Device	XC164CS-8F
Marking/Step	(E)ES-BB, BB
Package	PG-TQFP-100-5, P-TQFP-100-16

This Errata Sheet describes the deviations from the current user documentation.

Figure 1 Example for Case 2: Interrupt Service for Task C delayed

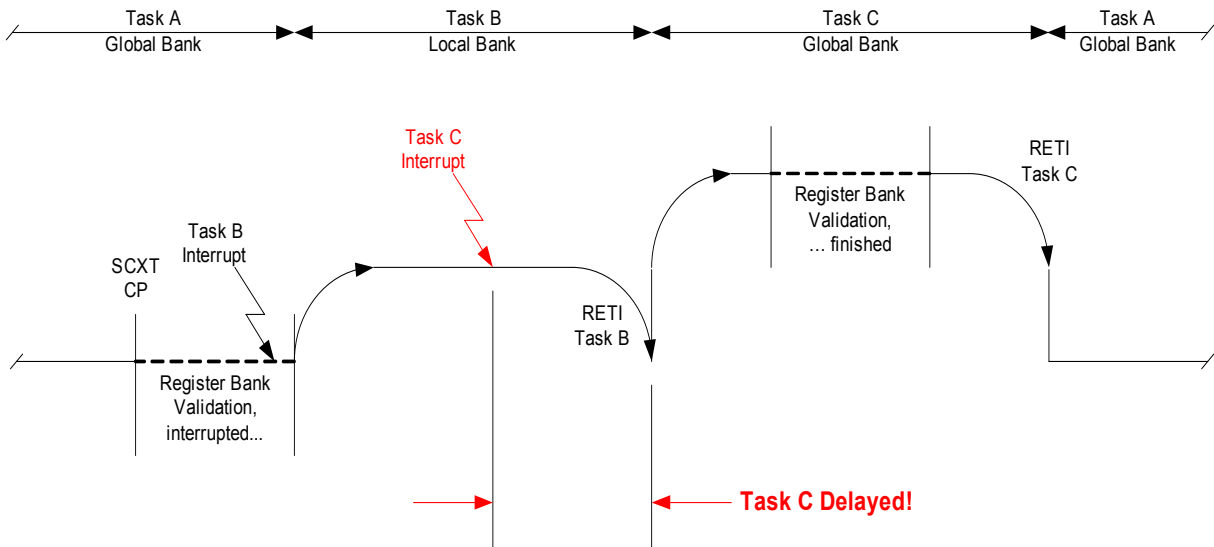
Case 2 (see also Figure 1):

- The Context Pointer CP is written to (e.g. by POP, MOV, SCXT .. instructions) within a routine (Task A) that uses a **global** register bank (bit field PSW.BANK = 00_B), i.e. the context for this routine will be modified,
- This context switch procedure (19 cycles) is interrupted by an interrupt request (Task B) which is programmed (with GPRSELx = 1X_B) to automatically use one of the **local** banks via the bank selection registers BNKSEL0..3 (i.e. the interrupting routine has a priority level ≥12),
- Before the corresponding interrupt service routine is finished, another interrupt request (Task C) occurs which is programmed (with GPRSELx = 00_B) to automatically use the **global** bank via the bank selection registers BNKSEL0..3 (i.e. the interrupting routine has a priority level ≥13)

In this case service of this interrupt request (for Task C) is delayed until bit field PSW.BANK becomes 00_B after executing the RETI instruction at the end of the routine (Task B) using the local bank.

Workaround for Case 2

When using both local and global register banks via the bank selection registers BNKSEL0..3 for interrupts on levels ≥ 12 , ensure that there is no interrupt using a global register bank that has a higher priority than an interrupt using a local register bank.
